UNITED STATES PATENT AND TRADEMARK OFFICE

10/802,283

Office Action Summary

DETAILED ACTION

FIGURE A

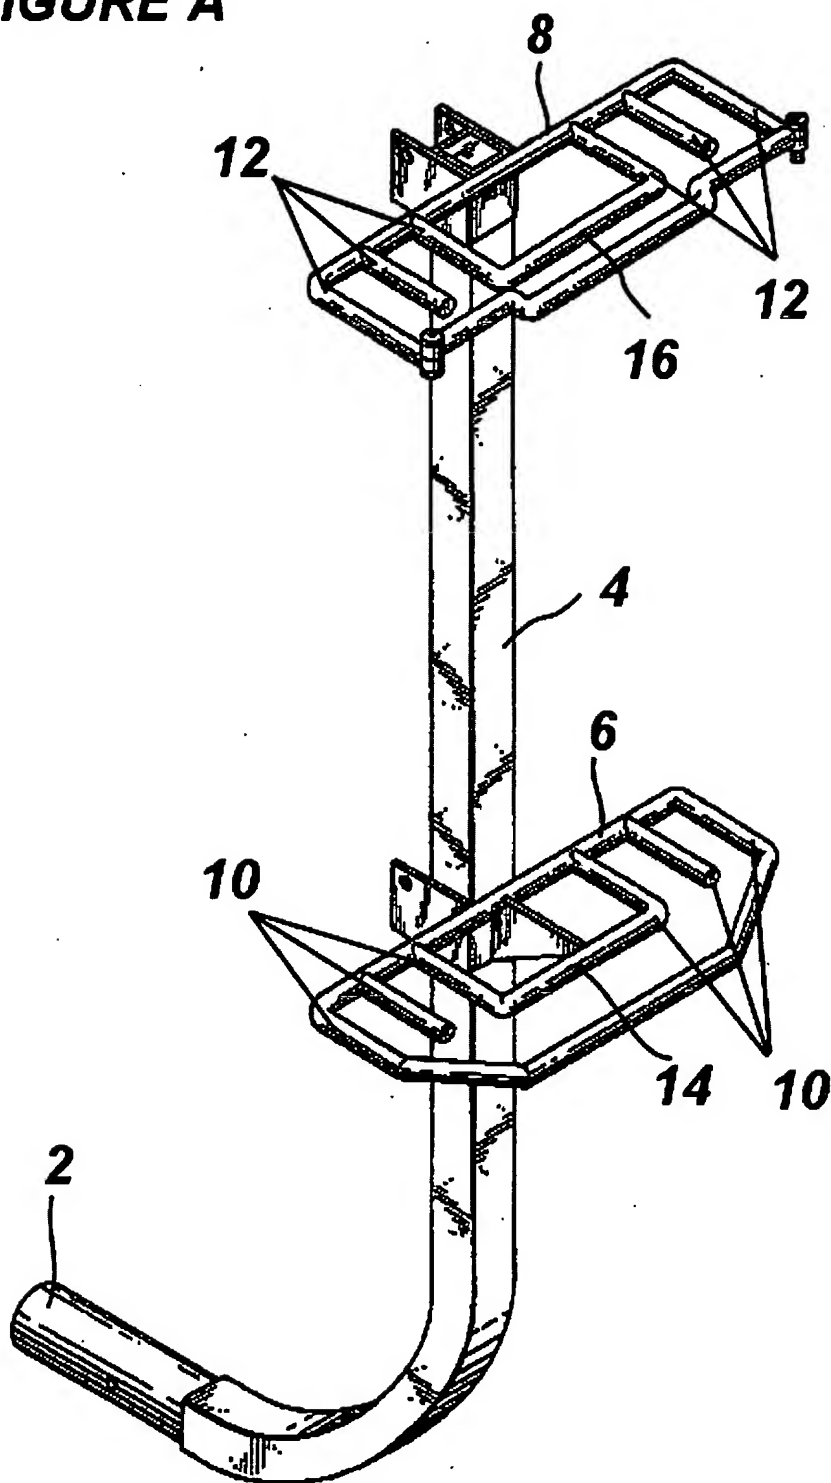
Regarding claims 1, and 7-8, Eckhart (shown Figure A below) discloses the invention substantially as claimed including: a hitch support member 2 capable of being mounted to the rear of a vehicle; a vertical support member 4 connected to the hitch support; a first horizontal crossbar 6 connected to the vertical support; a second horizontal crossbar 8 disposed above the first crossbar; and a plurality of transverse bars 10 and 12 connected transversely to the horizontal crossbars, the transverse bars able to secure the load. Eckhart does not have a load-carrying platform. However, Goodness teaches the use of a load-carrying platform 118 connected to hitch member

Regarding claim 12, the modified Eckhart device discloses the invention with horizontal connecting members 14 and 16 (Figure A below) further connecting the transverse bars, and located opposite the horizontal crossbars.

Regarding claims 21 and claim 23, the modified Eckhart device discloses the claimed invention wherein the means for securing the load is comprised of first and second horizontal crossbars 6,8 with a plurality of transverse bars 10,12 connected thereto, the load platform supporting the load and the transverse bars securing the load.

Regarding claim 24, the modified Eckhart device discloses the invention with horizontal connecting members 14 and 16 further connecting the transverse bars, and located opposite the horizontal crossbars.
